15th Ave & Ballard Bridge Repaving Project

Pedestrian, Bicycle, and Road User Improvements

Date: December 10th, 2022

Over the weeks leading up to December 4th 2022, members of the Ballard-Fremont Greenways conducted reviews of the [60% plan provided by SDOT](#) for the repaving of 15th Ave and the Ballard Bridge, along with its alignment with the [Pedestrian](#) and [Bicycle master plans](#), the [Complete Streets Ordinance](#), and concluded with a walk audit of the project site.

15th Ave & W Emerson

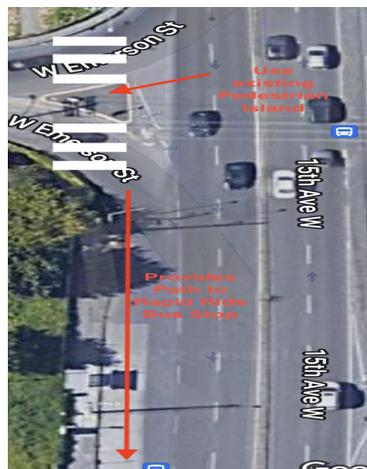
1. There is no ADA accessible crossing at Emerson when crossing from the Ballard Bridge towards the Pedestrian Island, or from the Pedestrian Island to continue Southbound on 15th Ave on Emerson

2. We believe the existing Bike Sharrow is not just pointless, but is dangerous for cyclists unfamiliar with the route. 15th Ave is ***not a road that is remotely safe or friendly for cyclists***

We recommend improving this intersection with an ADA accessible crosswalk connecting the path from the Ballard Bridge to Southbound 15th Ave, as shown below:

The Ballard Bridge

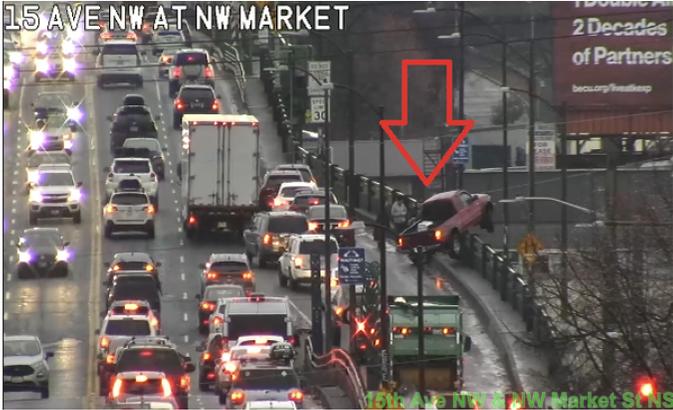
While the Ballard-Fremont Greenways would highly recommend SDOT consider reclaiming one lane of traffic across the Ballard Bridge for a two-lane cycle track, in case SDOT does not pursue that option, we do have other concerns for this route in its existing state of use. Specifically, the large portions of the Ballard Bridge which have nothing more than an 8" curb separating pedestrians and cyclists from vehicular traffic.

[As was reported on November 22nd, 2022](#), the lack of railing or sufficient separation of vehicular traffic from both the pedestrian path and the drop off of the Ballard Bridge is a grave danger to **all bridge users**.

A relatively easy way to improve pedestrian safety is to simply extend the railing which exists in the central portion of the Ballard Bridge near the drawbridge, down either end.

In addition to extended railings, we highly recommend improved signage along the Ballard Bridge to raise awareness among drivers that walking and rolling users of this infrastructure exist.
